Subject: Hawaiian Memorial Park Expansion

Re: LUC No. A17-804 Hawaiian Memorial Life Plan, Ltd.; 2025 Status Report

In response to your letter dated April 28, 2025, I offer the following comments on the three sediment traps you suggest should remain in place:

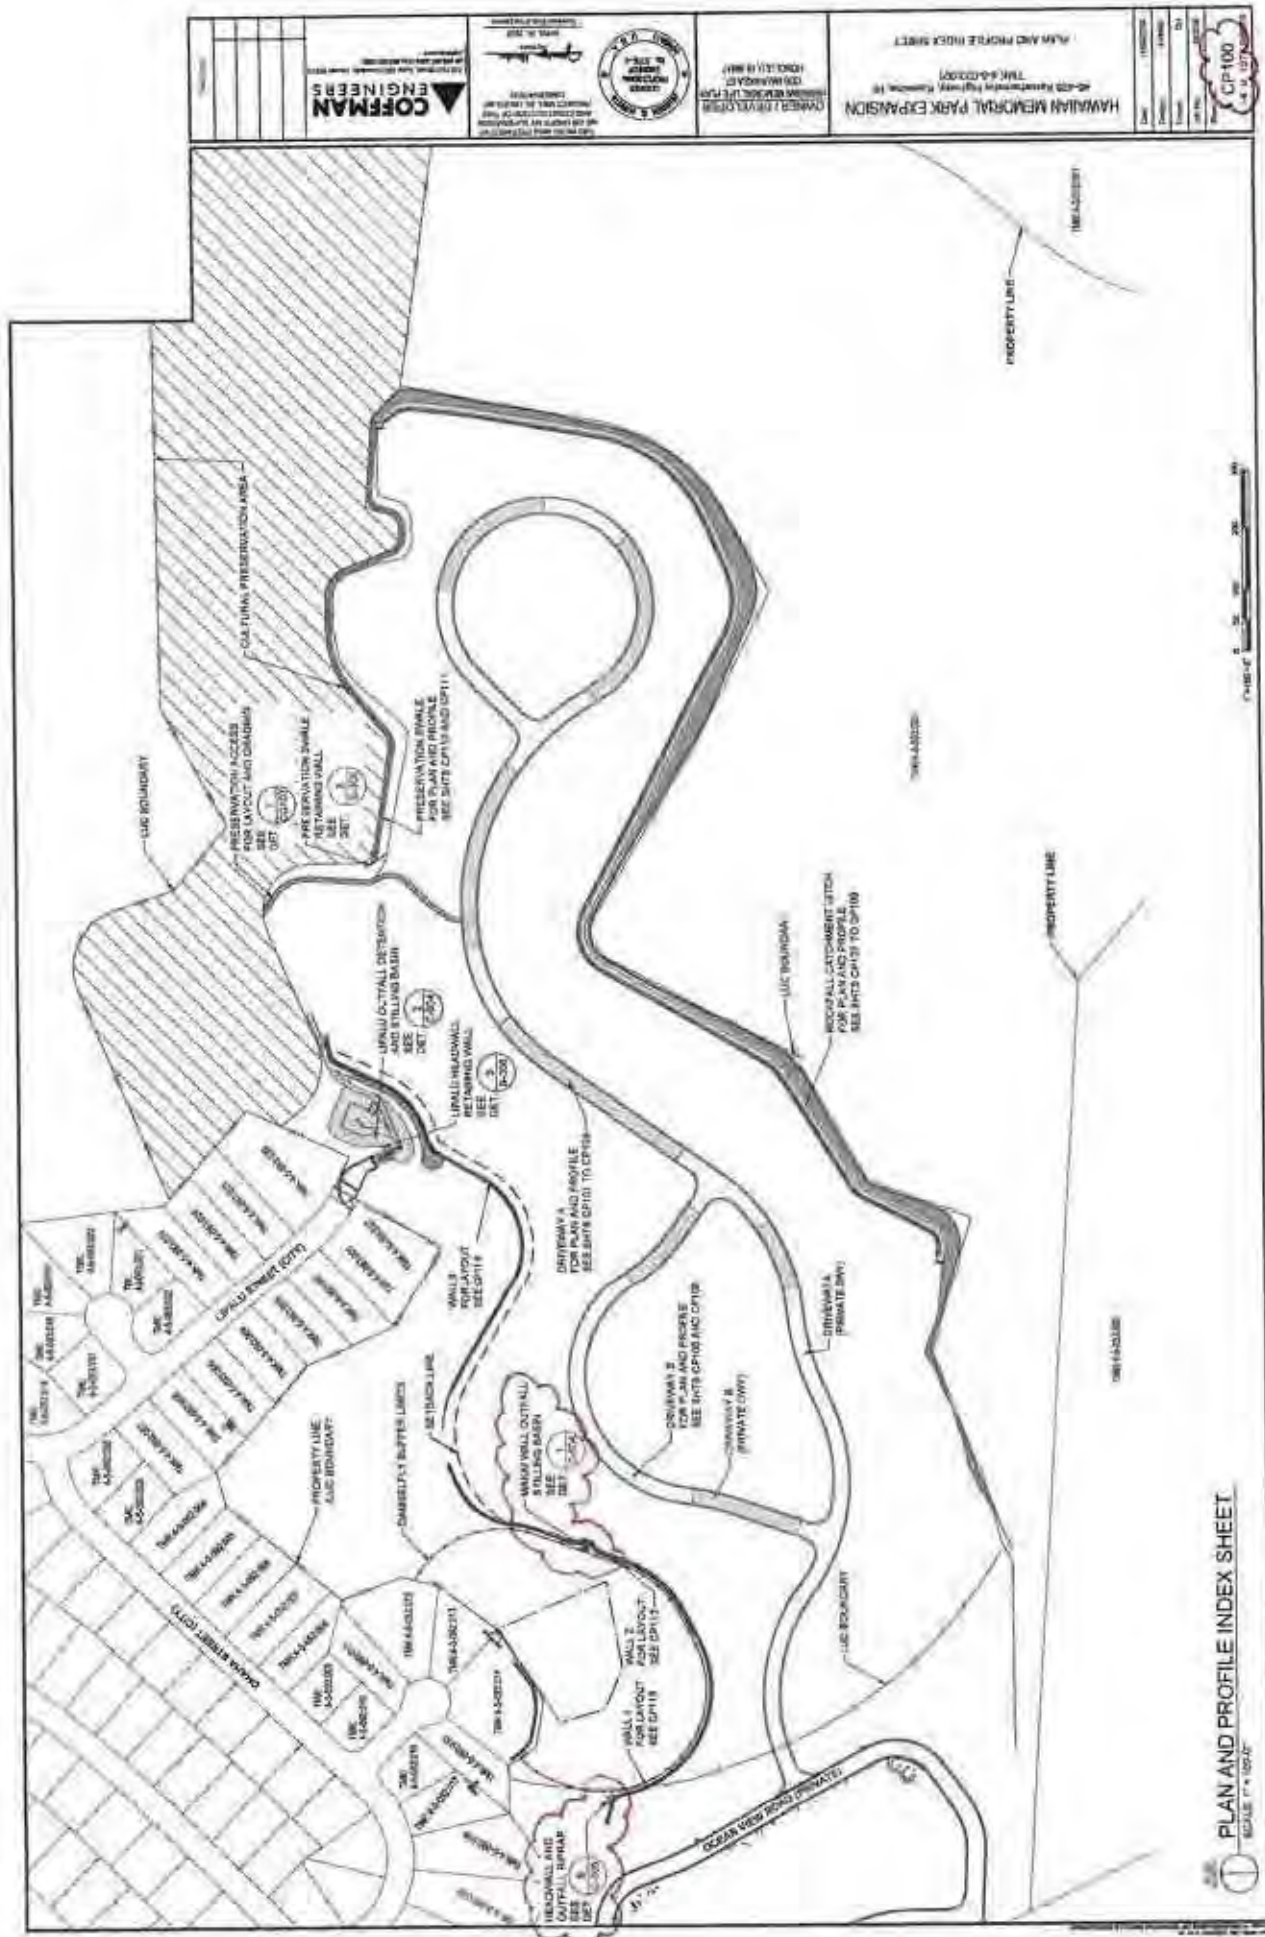
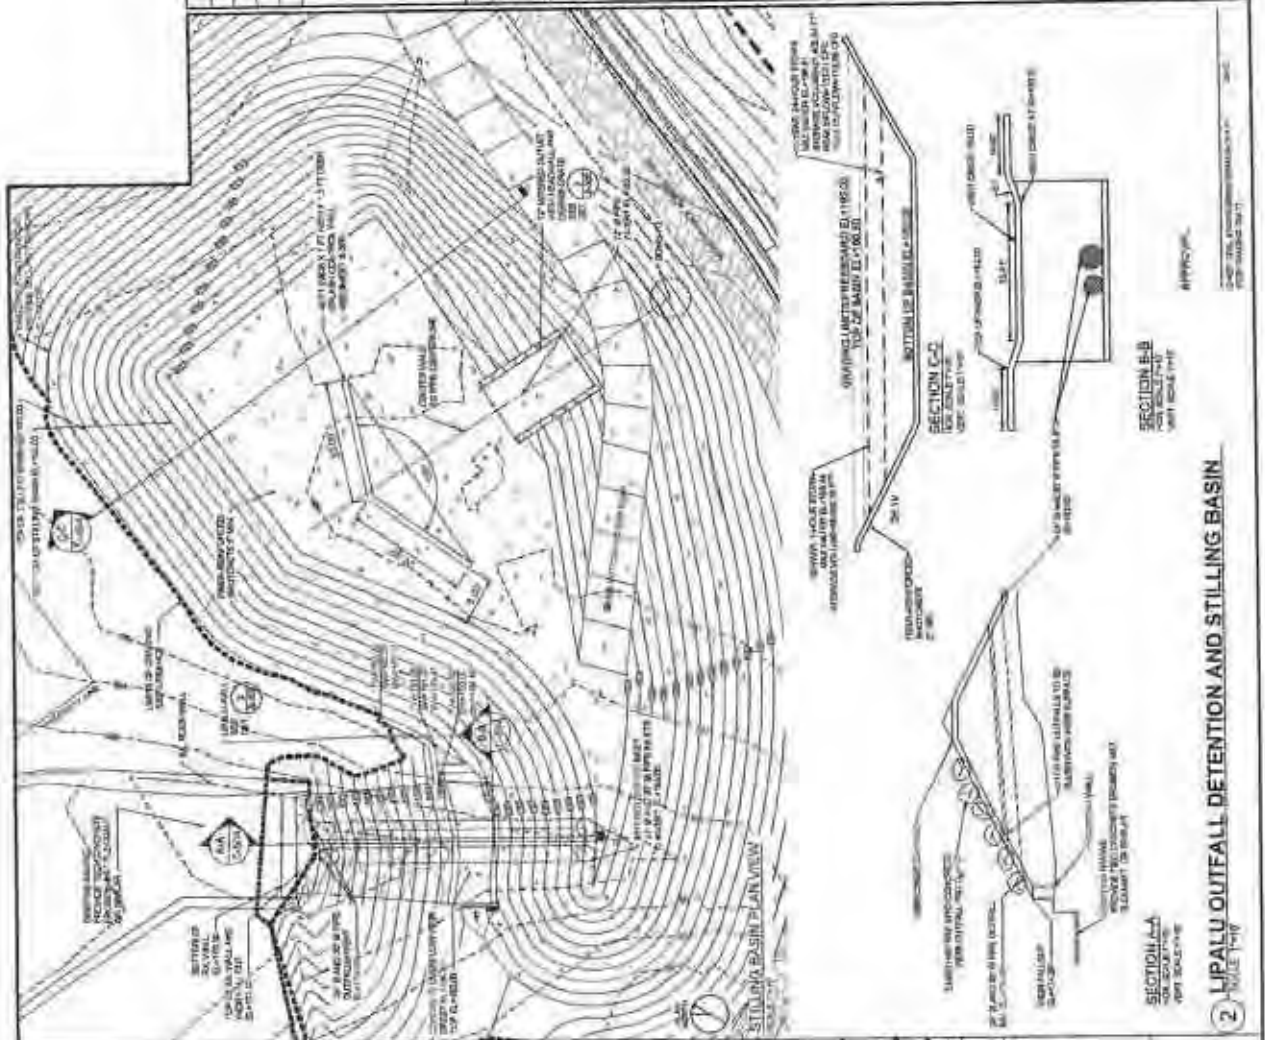
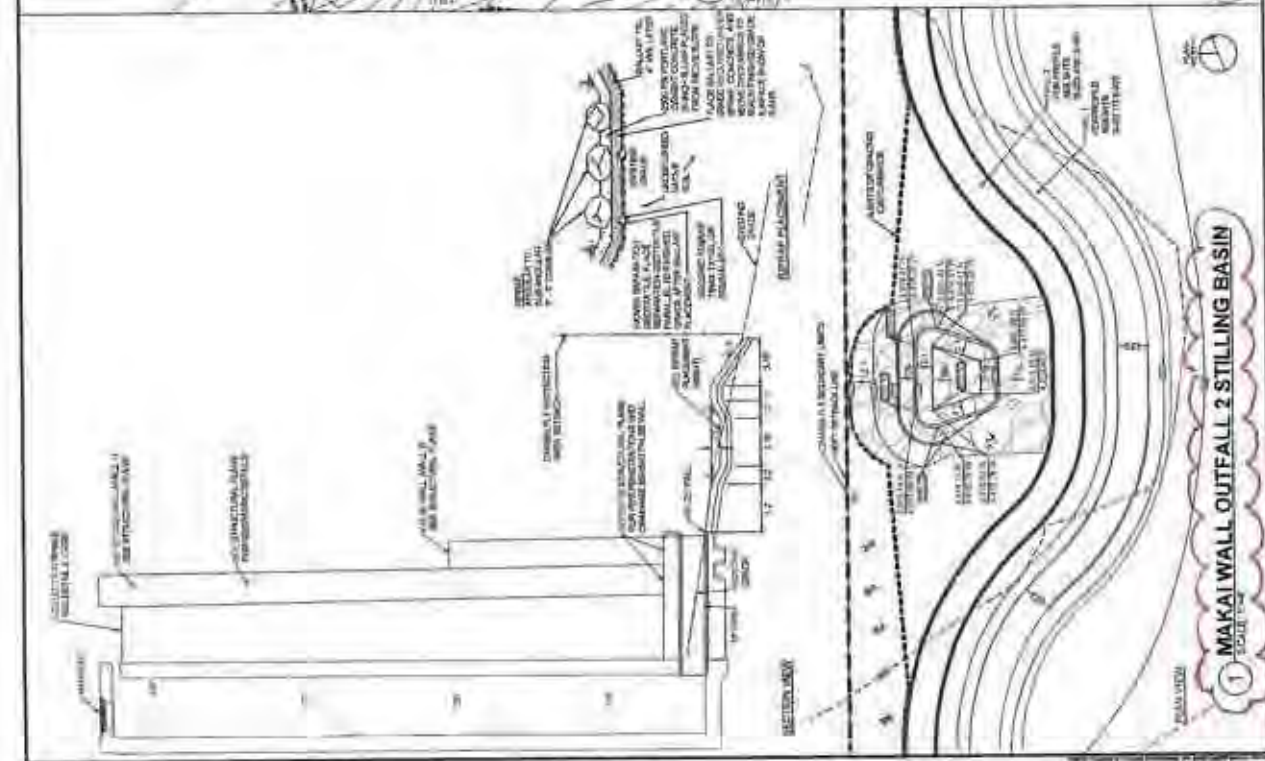
Sediment Trap 2 (with a capacity of 5,106 Cubic Feet, see attached Sheet C-100) appears to be outside the limits of grading, but within an area referred to as "additional limits of disturbance", presumably the "disturbance" required to construct Sediment Trap 2. This sediment trap sits in a natural gully directly upstream from the last existing home on the west side of Lipalu Street which has no backyard drainage inlet but an unlined earth "cutoff" ditch running from the backyard to the street along the mauka property line. Since Sediment Trap 2 is outside the limits of grading it can't be "in the way" of the proposed development. Why can't it be left in place as some additional measure of protection? Wouldn't the developer save money by not having to remove it?

Sediment Trap 3 (with a capacity of 12,966 Cubic Feet, see attached Sheet C-100) appears to be immediately adjacent to the much smaller proposed permanent "Makai Wall Outfall 2 Stilling Basin" (see Sheet CP-100 and Detail #1 on Sheet C-504) both of which are directly upstream of the small backyard drainage inlet behind the home (TMK: 4-5-092:013) at the end of Ohaha Place. It would be much safer for the owner of that home if Sediment Trap 3 was left in place but it would require some changes to the proposed grading in that area. Is that too great a price to pay for a little more safety for that homeowner and the community?

Sediment Trap 4 (with a capacity of 10,012 Cubic Feet, see attached Sheet C-100) appears to be immediately adjacent to the much smaller proposed permanent "Makai Wall Headwall and Outfall 1 Riprap" (see Sheet CP-100 and Detail #6 on Sheet C-505) both of which are directly

upstream of the small backyard drainage inlet behind the home (TMK 4-5-092:017) on Ohaha Street that is one lot west of Ohaha Place and also appears to drain across the backyard of the home (TMK 4-5-092:015) on the west side of the cul-de-sac at the end of Ohaha Place. It would be much safer for the owners of those two homes if Sediment Trap 4 was left in place but it would also require some changes to the proposed grading in that area. Is that too great a price to pay for a little more safety for those two homeowners and the community?

Each of these Sediment Traps are directly up stream from relatively small existing drainage inlets/ditches in the backyards of existing homes. The four relatively small existing "backyard" drainage inlets/ditches show up best on Sheet CG-100 (see attached).

Immediately adjacent to and upstream of Sediment Trap 4, the plans call for the installation of a new 30" diameter drainline discharging into a very small basin (see Detail #6 on the attached Sheet C-505) that will overflow in storms and flow directly down to the backyard drainage inlet in the backyard of TMK 4-5-092:017 that appears on the as-builts for the subdivision, to only have an 18" diameter pipe to convey the runoff from the 30" diameter pipe, between the two adjacent houses, to the street. That seems like a potentially serious problem just waiting for a flash flood to occur, especially without Sediment Trap #4 remaining on a permanent basis.

As you noted, Trap #2 is located in a natural gully upstream of the last home on the west side of Lipalu St. Upon the completion of construction, this area will sit below the proposed retaining wall #3 shown in the construction drawings. Runoff flowing into this gully will be cut-off by the proposed wall and directed into the new drainage system discharging into the Lipalu St outlet. Converting this trap to a detention basin will provide little benefit to the neighbors because little to no runoff will enter this area.

In the proposed condition, Sediment Trap #3 is located directly behind retaining wall #2. The runoff behind the wall will be collected in a concrete swale and conveyed to the proposed drainage system. The existing grades in this area are approximately 40' lower than the proposed grade. Leaving the trap in place is not possible given the amount by which we will be raising the grade and the new retaining wall that will be constructed. Building a new detention basin in this area will have a direct impact on the amount of developable land available to HMP in an area where the improvements have already been shown to reduce the runoff to adjacent neighbors.

Similar to the condition noted above, Sediment Trap #4 is located directly behind retaining wall #1. The new wall will have a concrete swale directing water directly into a storm drain manhole and through the existing outfall. The existing grades in this area are approximately 20' lower than the proposed grade. Leaving the trap in place is not possible given the amount by which we will be raising the grade and the new retaining wall that will be constructed. Constructing a new detention basin in this area will have a direct impact on the amount of developable land available to HMP in an area where the improvements have already been shown to reduce the runoff to adjacent neighbors.
